PROJECT :
AIR COOLER FOR
Toase-ehe Park Sanati Gohar Ofogh Petrochemical Co.
rrangement Drawing
A01-1000-00

DWG. NO.	EI027-DMF-VD-ME-DWG-003	
SCALE : N.T.S.	SIZE : A1	REV. : R2

FRONT VIEW
CL. A,C

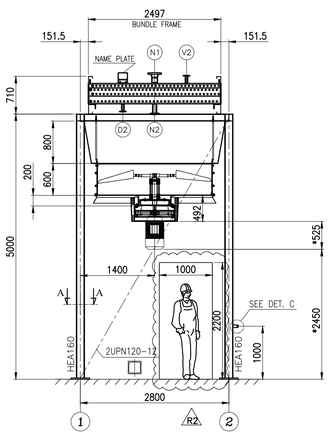
Repetitive comment:
Please show the raise of flange, and set the dimension with it.

On page 3/10 of fan data sheet , fan ring diameter is 2156.
on page 4/10 of fan data sheet, fan ring diameter is 2155.
please remove the discrepancy and clear it. All related documents to be matched.

SIDE VIEW

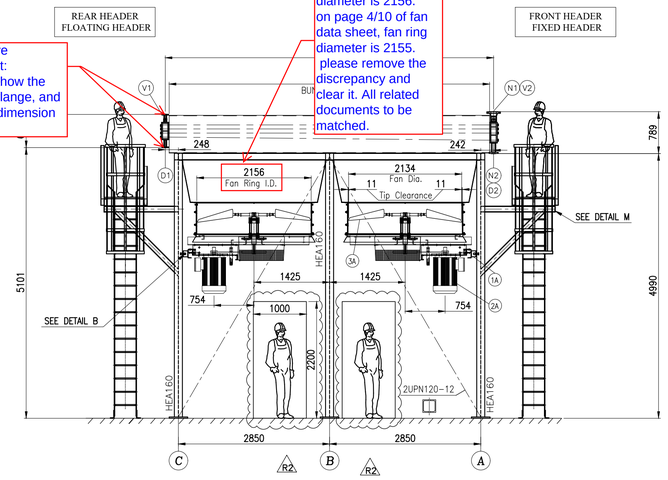
Please add a sketch for lifting the bundle.

Please specify and show the support of cable tray for vibration switch.

BASE PLATE VIEW

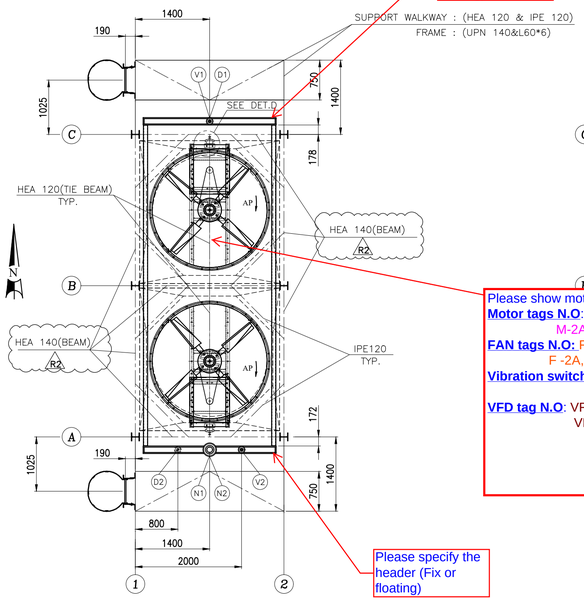
Please specify the header (Fix or floating)

Please show motor, Fan, Vibration switch,VFD tag N.O as following :
Motor tags N.O: M-1A, M-1B for unite 1
M-2A, M-2B for unite 2
FAN tags N.O: F-1A, F-1B for unite 1
F -2A, F-2B for unite 2
Vibration switch tag N.O: VS-1A, VS-1B for unite 1
VS-2A, VS-2B for unite 2
VFD tag N.O: VFD-1 for unit 1
VFD-2 for unit 2

DET. M

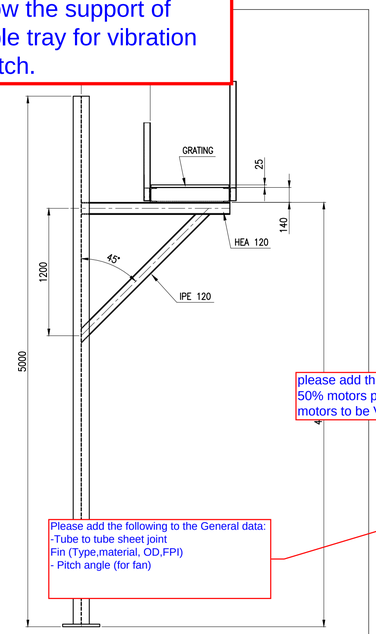
please add this note:
50% motors per unit to be VFD. All motors to be VFD compatible.

Please add the following to the General data:
-Tube to tube sheet joint
Fin (Type,material, OD,FPI)
- Pitch angle (for fan)
